Access Compliance Report Public Rights-of-Way (Curb Ramps)

Main Street: SENDERO WAY Cross Street: NACIENTE ST Location: SE

ADA ID: RPRK211116141818 Ramp Type: Type 4 - Parallel Initial Pass/Fail: Fail Overall Compliance: No Severity Score: 30

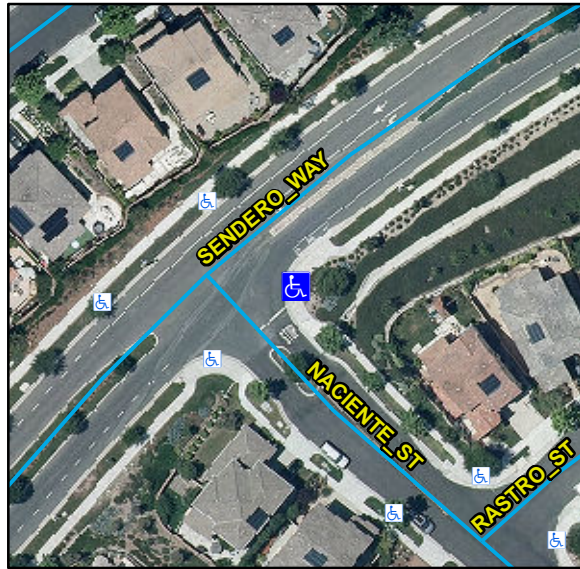
Compliance	Description	Data	Compliance	Description	Data
N/A	Ramp Length LT (in)	93	N/A	Ramp Length RT (in)	86
Yes	Ramp Width LT (in)	88	Yes	Ramp Width RT (in)	88
No	Ramp Run Slope LT (%)	18.6	No	Ramp Run Slope RT (%)	9.5
Yes	Ramp Cross Slope LT (%)	1.3	Yes	Ramp Cross Slope RT (%)	0.4
N/A	Landing Present	N/A	N/A	DWS Provided	N/A
N/A	Landing Length (in)	N/A	N/A	DWS Contrast	N/A
N/A	Landing Width (in)	N/A	N/A	DWS Length (in)	N/A
N/A	Landing Run Slope (%)	N/A	N/A	DWS Full Width	N/A
N/A	Landing Cross Slope (%)	N/A		DWS Offset Type	N/A
N/A	Landing Movement Obstructed?	N/A	N/A	DWS Offset Left (in)	N/A
	Landing Movement Type	N/A	N/A	DWS Offset Right (in)	N/A
N/A	Landing Shared	N/A			
N/A	Clear Space	Yes			
N/A	Clear Space To Crosswalk (in)	N/A			
N/A	Marked Crosswalk 1	No	N/A	Marked Crosswalk 2	No
	Crossing 1 Direction	N		Crossing 2 Direction	W
	Marked Crosswalk 1 Width (in)	N/A		Marked Crosswalk 2 Width (in)	N/A

Remove & Replace Curb Ramp With Two New Directional Ramps or Equivalent.
